Intel[®] IXP42X Product Line of Network Processors and IXC1100 Control Plane Processor

Specification Update

October 2004

Document Number: [252702-006](#)

HPI-16 Simplex Write Mode

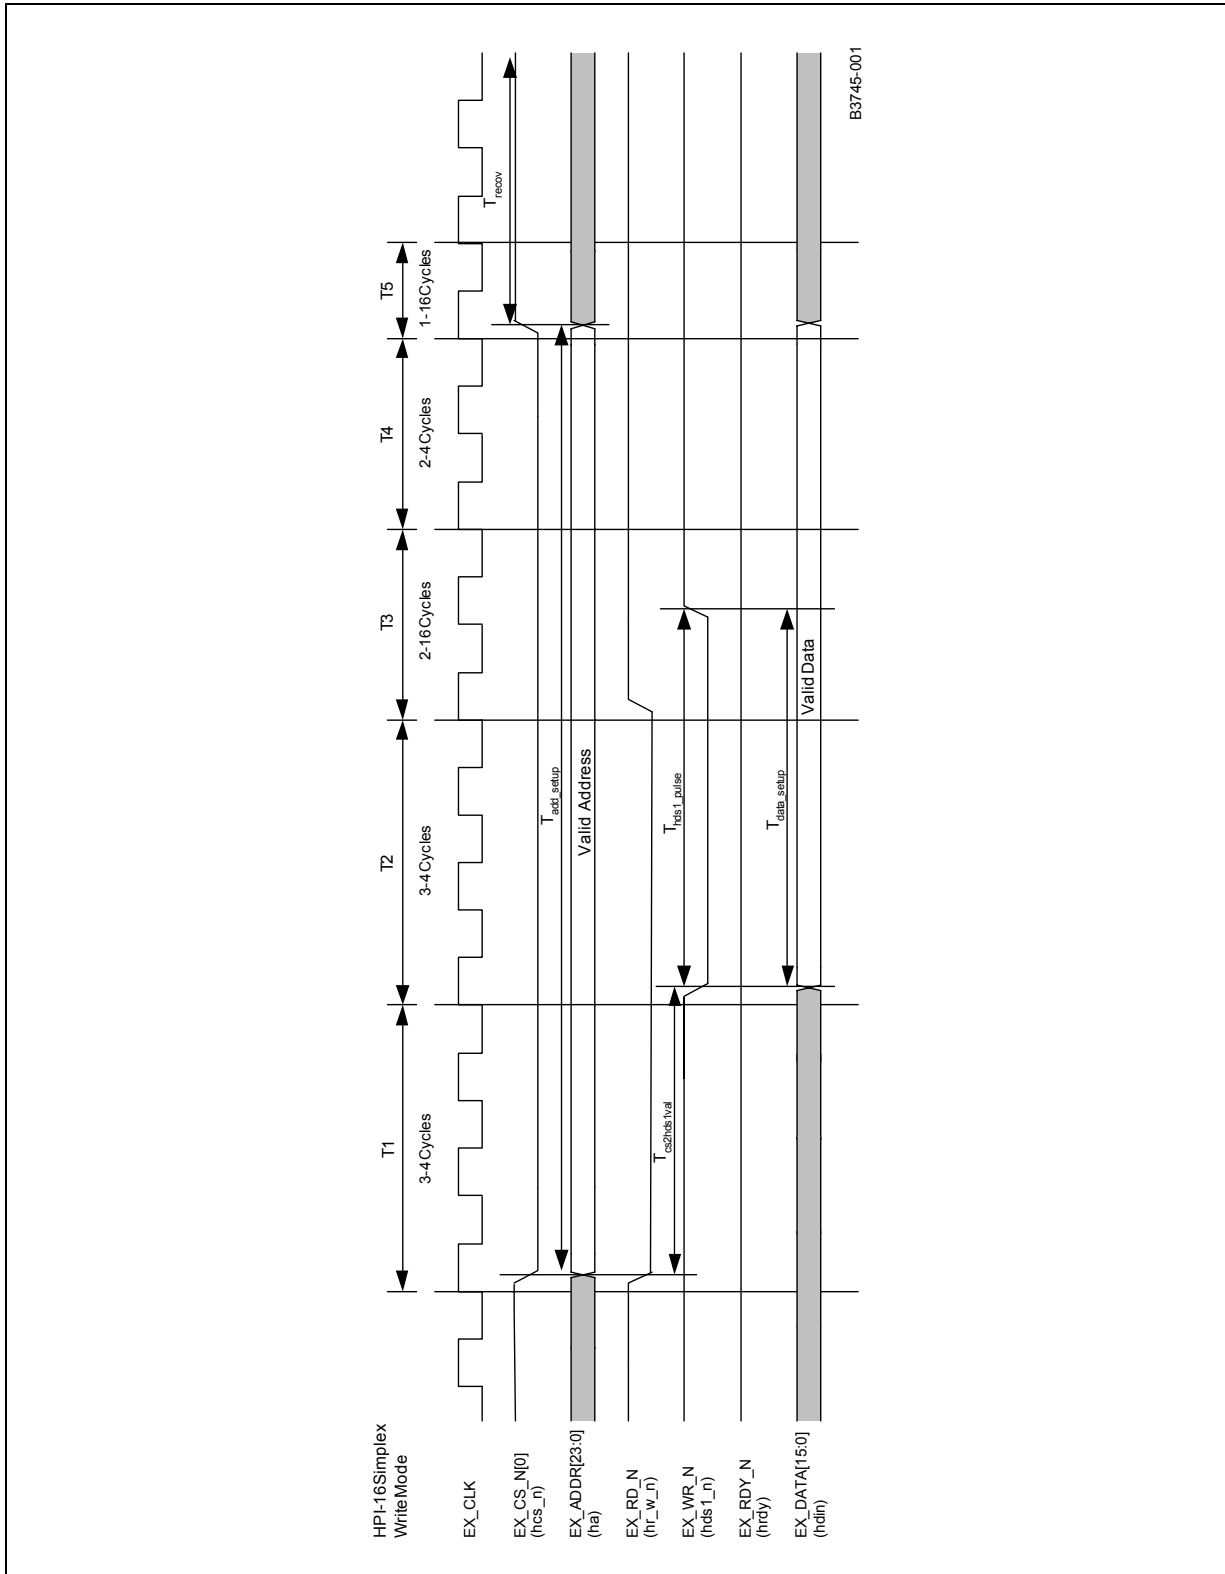
Replace datasheet Figure 34, “HPI-16 Simplex Write Mode”, with a new figure, “HPI-16 Simplex Write Mode”, which follows.
